Access Compliance Report

Public Rights-of-Way

(Curb Ramps)

Intersection ID: 53758	Main Street: PROSPERITY RIDGE RD	Cross Street: PROSPERITY RIDGE RD	Location: W
ADA ID: 79322256ECD8	Ramp Type: Perp	Initial Pass/Fail: Pass	Overall Compliance: No
Severity Score: 0			
Codes/Mitigation Info/Possible Solution		Field Measurements/Component Compliance

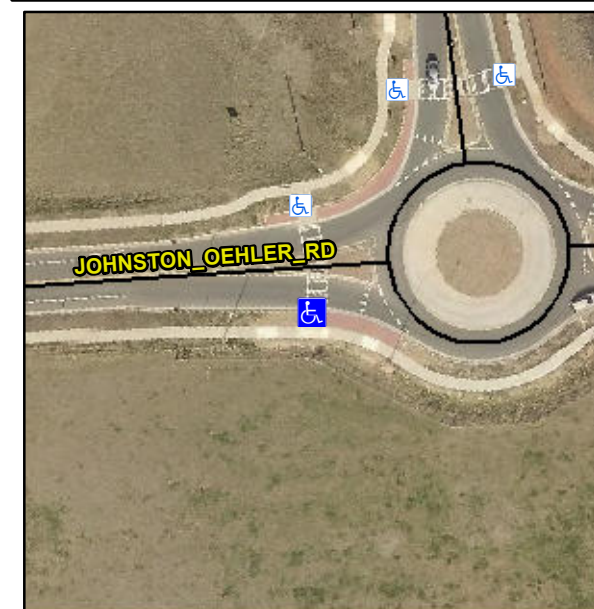
**R304.2.2-Perp, R304.3.2-Para,
R304.5.3, R305.2**

Compliance	Description	Data	Compliance	Description	Data
N/A	Ramp Length (in)	94.5	Yes	Ramp Slope (%)	7.8
Yes	Ramp Width (in)	72.5	Yes	Ramp XSlope (%)	1.8
N/A	Flare Type LT	Sloped	Yes	Flare Type RT	N/A
N/A	Flare Slope LT (%)	9.1	N/A	Flare Slope RT (%)	N/A
N/A	Flare Traversable LT?	Yes	N/A	Flare Traversable RT?	No
Yes	Landing Length (in)	72.0	Yes	DWS Provided?	Yes
Yes	Landing Width (in)	83.0	Yes	DWS Contrast?	Yes
No	Landing Slope (%)	3.4	Yes	DWS Length (in)	24.0
No	Landing X Slope (%)	2.7	Yes	DWS Full Width?	Yes
N/A	Landing Curb? (Y/N)	No	No	DWS Offset (in)	6.0
N/A	Shared Landing?	No			
Yes	Gutter Ponding?	No	Yes	Gutter Slope (%)	2.4
Yes	Gutter Lip Ht (in)	0.0	Yes	Gutter X Slope (%)	1.5
N/A	Painted X Walk1?	Yes	N/A	Painted X Walk2?	N/A
	X Walk 1 Direction	To N		X Walk 2 Direction	N/A
N/A	X Walk 1 Width (in)	112.0	N/A	X Walk 2 Width (in)	N/A
	X Walk 1 Slope (%)	0.3		X Walk 2 Slope (%)	N/A
	X Walk 1 X Slope (%)	2.2		X Walk 2 X Slope (%)	N/A

Yes	Ramp inside XWalk1?	Yes	N/A	Ramp inside XWalk2?	N/A
	Road Slope (%)	N/A	N/A	Clear Space?	Yes
	Road X Slope (%)	N/A	N/A	Clear Space to XWalk (in)	N/A
Yes	Any Obstructions?	No	Yes	Storm Grate/Utility Hazard?	No
	Obstruction Type			Storm Grate/Utility Type	
		N/A			N/A
			Yes	Surface Condition? (G/P)	Good

Remove & Replace Entire Ramp.
